Grants Reclamation Project

Homestake Mining Company of California

**RE: Revised HMC response to NRC's "Request for Additional Information – Compliance of Homestake Grants, New Mexico Site with 10 CFR 20.1301 and 10 CFR 20.1302." Docket No. 040-08903, License No. SUA-1471**

## Preface

**Figure 1: Radon versus distance study monitoring design.**

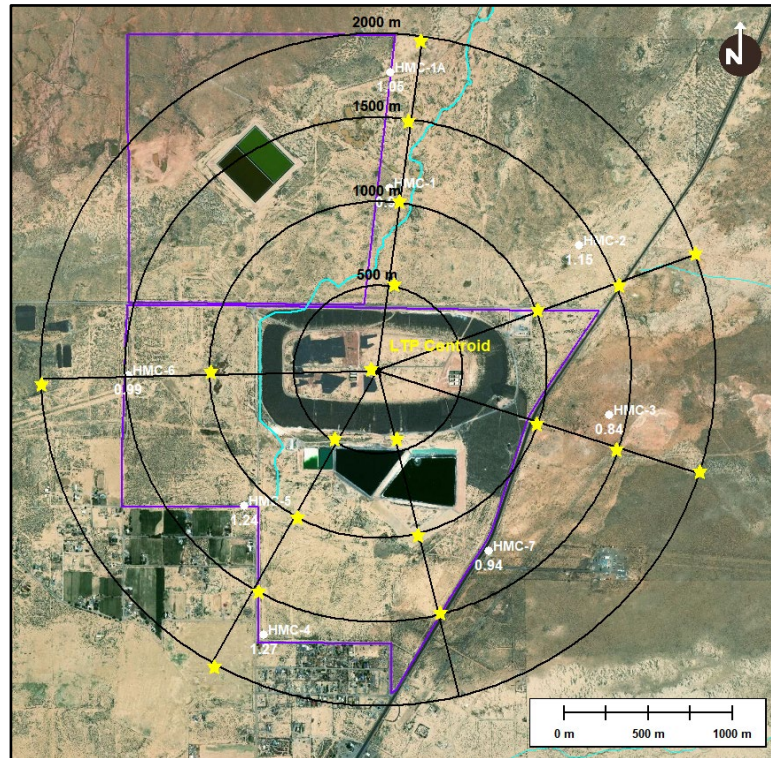
*HMC has not adequately demonstrated a method for compliance with 10 CFR 20.1301. As discussed with HMC staff, this proposed methodology is not consistent with any of the options recommended in the Interim Staff Guidance, DUWP-ISG-013, used for demonstrating compliance with 10 CFR 20.1301. More importantly, HMC did not provide justification why its proposed alternate methodology would insure that the maximum public dose from its operations would be within the regulatory limits.*

Evaluation of existing radon data and previous modeling efforts has raised questions as to whether this simplified conceptual ‘measure’ of net effluent radon, as defined in the ISG Radon Guidance, is a valid assumption for the Site. Accordingly, HMC has initiated a special study (beginning 1<sup>st</sup> quarter 2020) to evaluate ambient radon gas levels as a function of distance and direction from the approximate centroid of the LTP. Alpha track-etch detectors are posted on 500-meter increments along radial transects extending up to 2 km in the various directions and locations of boundary environmental monitoring stations (see Figure 1 below). The objective of the study is to characterize the spatial extent of measurable effluent radon emissions from the tailings piles, information that can be evaluated with current/historic boundary monitoring data and MILDOS modeling results to better inform the most effective and accurate method(s) for estimation of public dose on an annualized basis. This special study is consistent with recommendations and objectives found in Section 4.7 of the ISG Radon Guidance (NRC, 2019a), and results may eventually lead to the identification of a more accurate and reliable method for determining public dose from effluent radon emissions.

**Figure 2: Statistical comparisons of measured radon equilibrium ratios at locations relevant to evaluation of effluent radon properties and environmental behavior.**

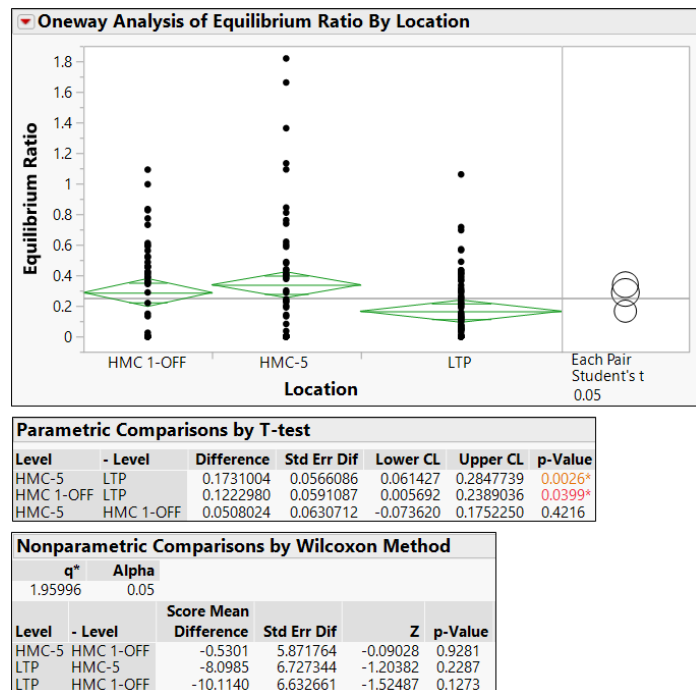
In the “Basis for Request” provided by NRC for RAI #4, the NRC cites a calculated equilibrium ratio of 0.34 at air monitoring station HMC-5 based on MILDOS modeling input data provided previously by HMC. At NRC’s request, HMC recently conducted a special study concerning occupational exposures at the Site, part of which included direct measurements of radon equilibrium ratio parameters at key locations, including the LTP, HMC-5 and HMC-10FF. Respective measurements included short-term grab sampling for radon gas (with a DurrIDGE RAD7 instrument) and measurement of radon progeny based on air grab sampling and analysis of sample filters using the modified Kusnetz method. These paired measurements, co-located in time and space, were scheduled twice per day (morning and afternoon) three days per week over an investigation period of approximately 4 months. Details of the methods and sampling design were provided in an associated Study Plan (ERG, 2017). Statistical comparisons of resulting equilibrium ratios by location as provided in the final Report (ERG, 2019) are reproduced as shown in Figure 2.

Aside from NRC questions regarding the quality of radon gas measurement data with the RAD7 instrument (USNRC, 2019b)<sup>2</sup>, the distribution of calculated equilibrium ratio results reveals a mean value of 0.34 at HMC-5, coincidentally matching the value calculated by NRC for this same location (see NRC’s Basis for RAI #4). As might be expected, measured equilibrium ratios on top of the LTP are statistically lower than other locations as radon emissions from the LTP are “fresh”, consisting only of radon gas when first released from the soil surface.

Because measured equilibrium ratios vary considerably (temporally and spatially) and the Study period was limited (about 4 months), and since there is uncertainty in both direct measurement and modeling of equilibrium ratios, HMC proposes to use conservative generic values specified in the ISG Radon Guidance as generally acceptable to NRC staff (USNRC, 2019a). The nearest member of the public represents a residential scenario with combined indoor/outdoor exposures, and a radon equilibrium ratio of 0.5 will be used for future calculation of public dose from radon gas/progeny. Results will be reported annually in 2<sup>nd</sup> half semiannual 40.65 reports.

**Figure 3: Statistical comparison of indoor radon gas levels between the Office the RO plant.**

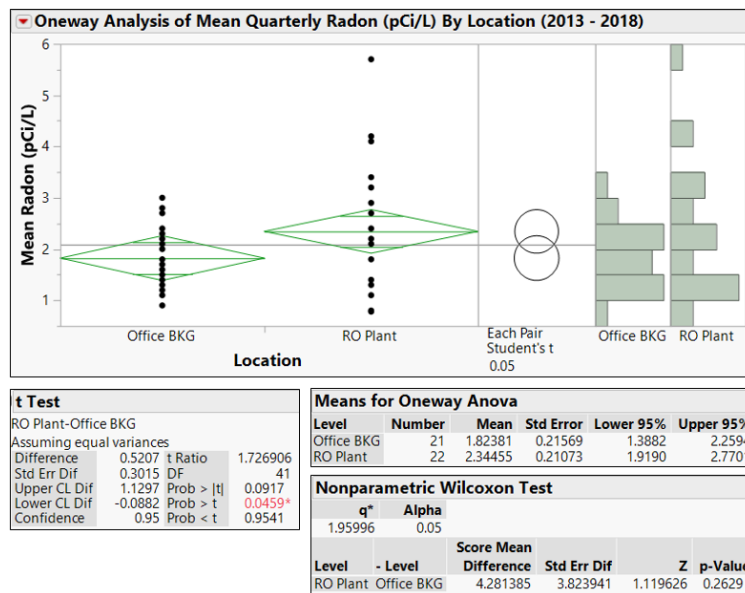
*Comment: The licensee described estimates of radon effluent quantities from the occupied spaces in the reverse osmosis (RO) building and the surface of the evaporation ponds. However, as discussed with HMC staff, there are other potential sources of radon that should also be evaluated.*

*Based on the licensee's descriptions (e.g., HMC, 2017<sup>3</sup>), the NRC staff understands the RO clarifier, which is an open-air tank outside the RO building, and which serves as a receiver of tailings water from the large tailings pile and other untreated water, is a potential unmonitored source. In addition, the use of evaporation pond sprayers is another unmonitored source that can be estimated with site-specific parameters (e.g., EPA, 2010). The licensee should account for all potential radon sources or explain why they could not be a significant source of radon in air effluent. In any case, Regulatory Guide (RG) 8.37<sup>4</sup> provides one method for addressing unmonitored effluents. This RG states, "The licensee should estimate the magnitude of unmonitored releases and include those estimated amounts when demonstrating compliance with dose limits and the licensee's ALARA goals." As discussed with HMC staff, HMC has not provided sufficient information for NRC staff to make a determination that HMC has established a methodology to account for all monitored and unmonitored sources of radon in air effluent.*

The total annualized ventilation rate for the RO building is estimated to be 1.12E+12 L/yr (based on summation of flow rates for all exhaust fans). A statistical comparison of quarterly average radon gas concentrations measured in the main office building and in the RO building over the past 5 years is shown in Figure 3.

The main office is considered representative of background indoor radon levels for onsite buildings. The net difference in these average values (0.52 pCi/L) is assumed due to RO treatment of groundwater containing 11e.(2) byproduct material. Based on these parameters, the calculated release of radon gas from the RO plant is 0.6 Ci/yr, less than 0.1% of total radon effluent releases from the tailings piles in 2018.
